International
Aero Engines

V2500 Propulsion System — Nacelle

SERVICE BULLETIN

NACELLE — ELECTRICAL POWER — POWER FEEDER HARNESS, VARIABLE SPEED
CONSTANT FREQUENCY (VSCF) GENERATOR — GROUND TERMINAL ATTACH BOLT,
AND POWER FEEDER HARNESS SUPPORT CLAMPS — REPLACEMENT OF

POWER FEEDER GROUND TERMINAL BOLT AND CLAMP REPLACEMENT - LH ENGINE
FIGURE 1.

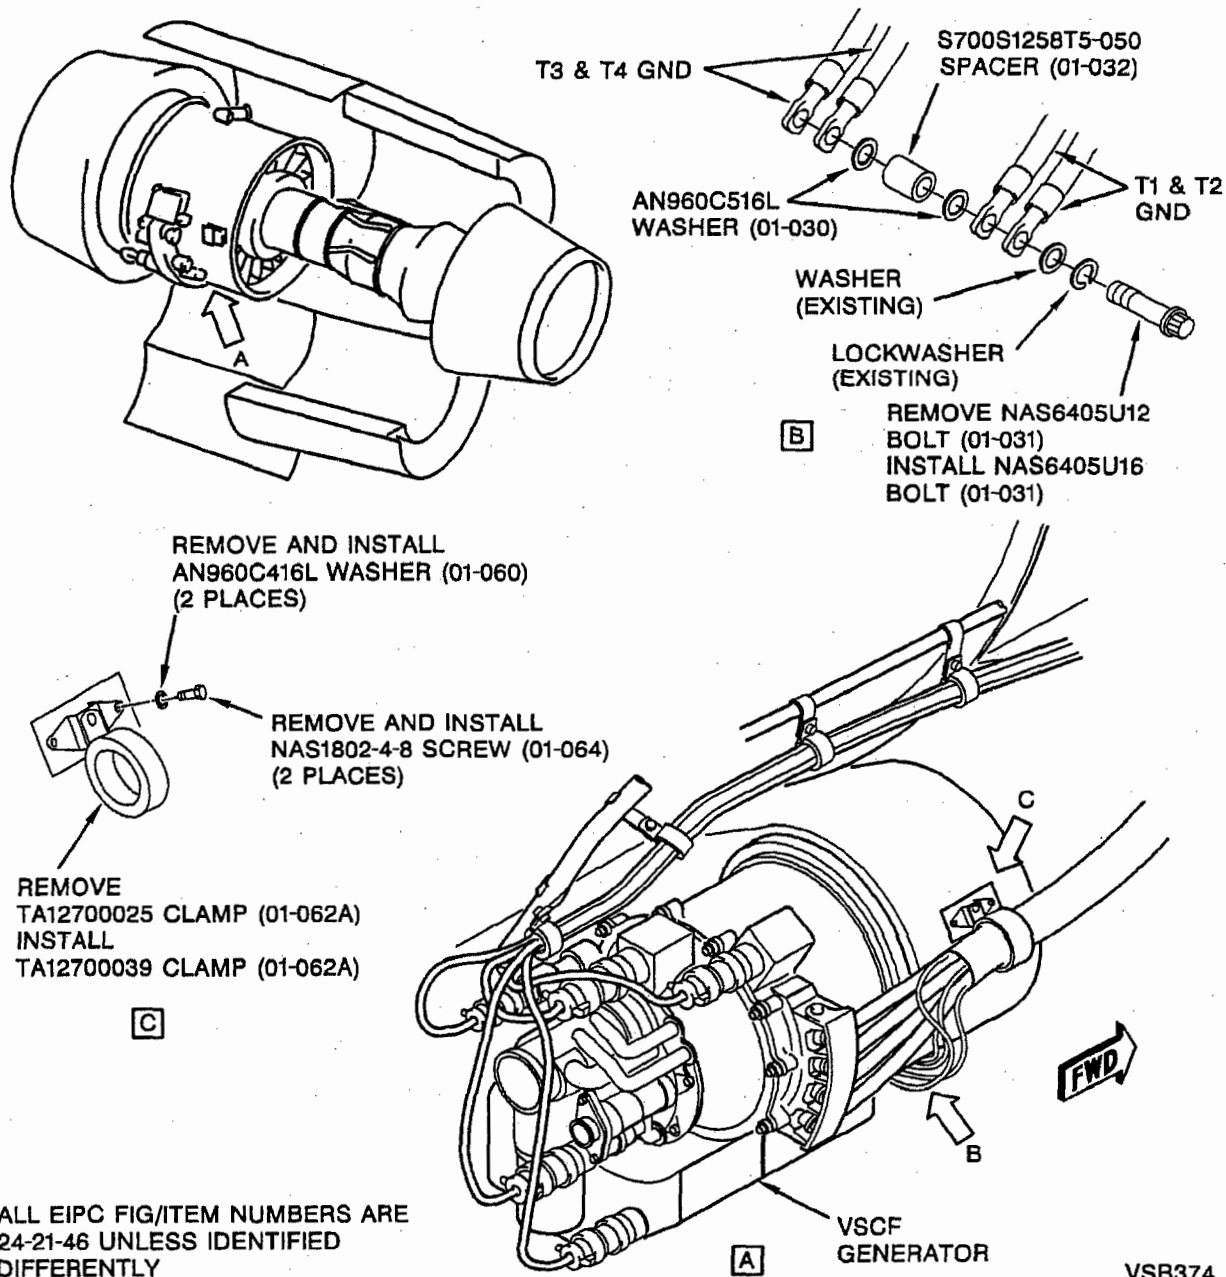
The addition of the overbraid to the VSCF feeder cable introduced in Service Bulletin V2500-NAC-24-0006 increased the diameter of the harness requiring larger clamps. Continued use of the existing clamps may cause wear to the harness.

The depth of thread for the bolt introduced in Service Bulletin V2500-NAC-24-0006 used to attach the VSCF power feeder cable ground terminals to the VSCF generator was incorrectly calculated, which may make the bolt difficult to install.

Replace the ground terminal attach bolt with a longer grip length bolt and replace selected power feeder support clamps with larger clamps.

- (1) Install the left hand engine NAS6405U16 VSCF power feeder ground terminal bolt.
 - (a) Install the NAS6405U16 bolt (24-21-46, 01-031), four VSCF ground terminals, S700S1258T5-050 spacer (24-21-46, 01-032), two AN960C516L washers (24-21-46, 01-030), and existing plain washer and lock washers on the VSCF generator. Refer to Figure 1.

- (2) Repeat step (1) above for the right hand engine. Refer to Figure 2.
- (3) Install the left hand engine TA12700039 power feeder support clamp.
 - (a) Attach the TA12700039 clamp (24-21-46, 01-062A) to the engine with two NAS1802-4-8 screws (24-21-46, 01-064) and AN960C416L washers (24-21-46, 01-060). Refer to Figure 1.

- (b) Open the TA12700039 clamp, insert the VSCF power feeder cables, and close the clamp.
- (4) Repeat step (3) above for the right hand engine. Refer to Figure 2.
